PREVOST

WARRANTY BULLETIN

WB15-13

DATE :	MARCH 2015	SECTION :	16 - Suspension
EXPIRATION:	MARCH 2017		
SUBJECT :	IFS LEVEL VALVE CONTROL ROD POSSIBLE CONTACT

Figure 1

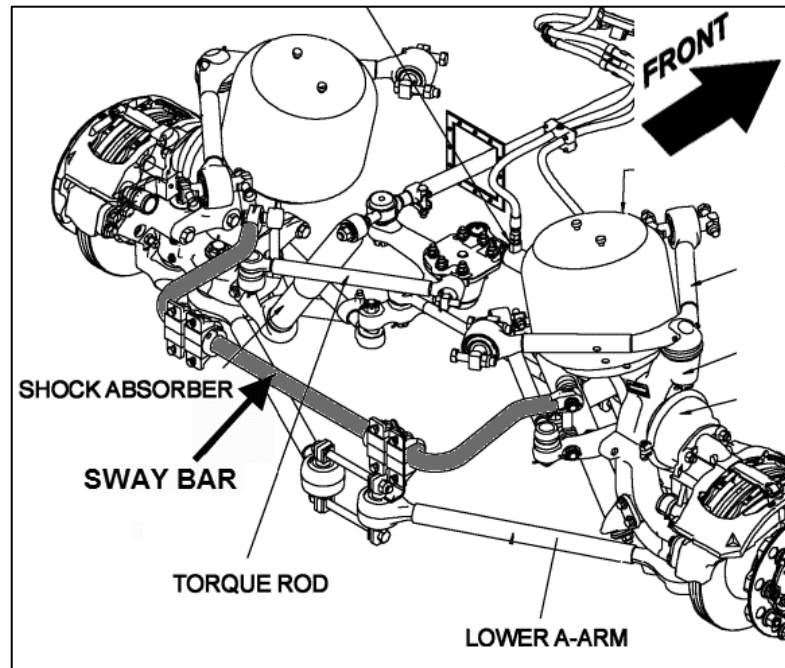
1. On the front axle, locate the front suspension sway bar. (Fig. 1)

Figure 2

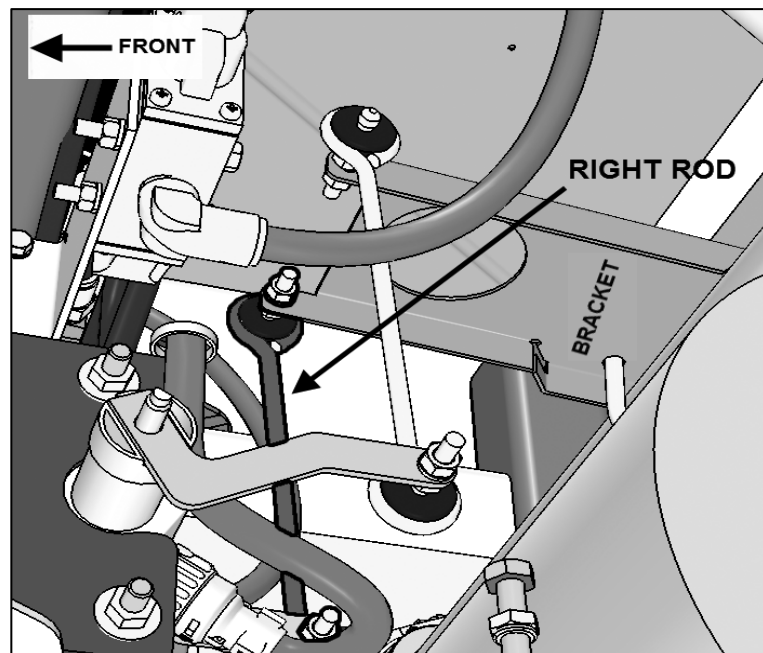
2. In the middle of the sway bar you will find a bracket clamped on the tube. The bracket supports two control rods (Fig. 2)

Figure 3 : Flip upper and lower connection of control rod.

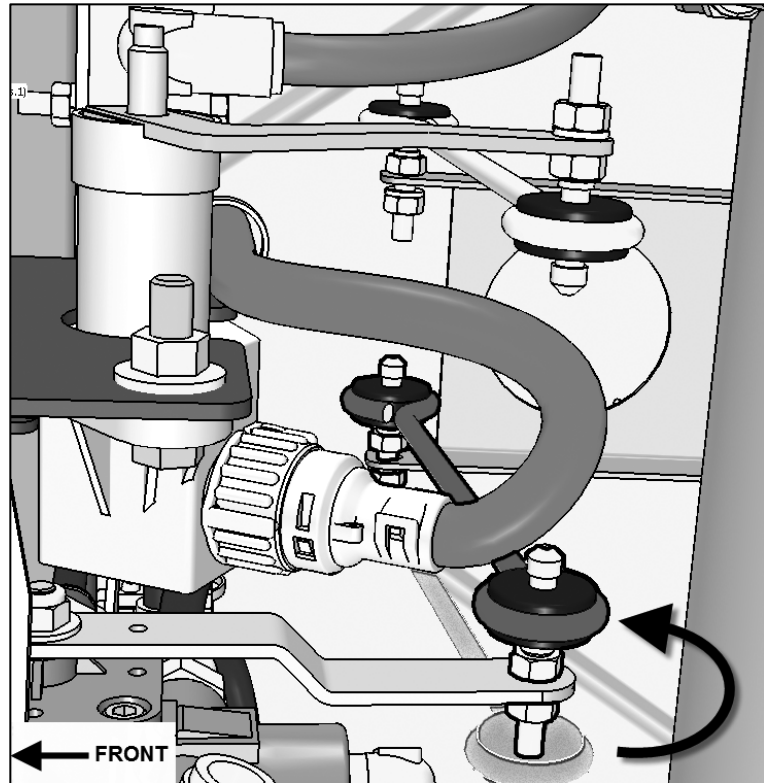
3. On the right hand side rod. (Fig.2) Unscrew the upper and lower mounting nuts.
4. Flip the rod over to the opposite side of the control lever and bracket tab above. (Arrow, Fig. 3)
5. Re-assemble hardware. (Fig.3)

Figure 4

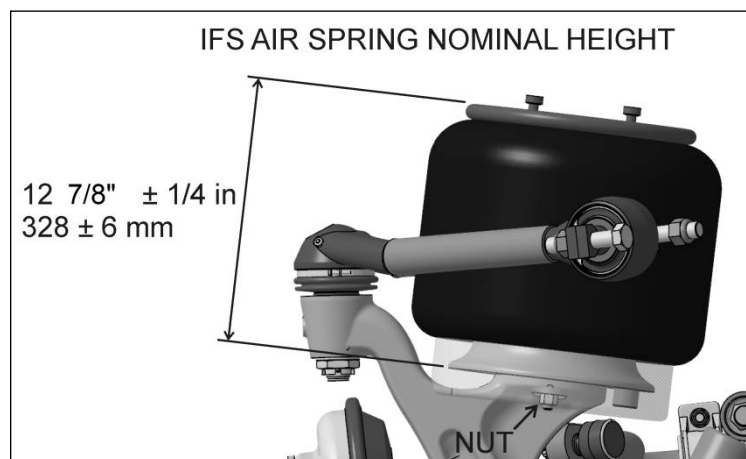
6. Adjust ride height to $12\frac{7}{8}'' \pm 1/4''$. (328mm $\pm$ 6mm)
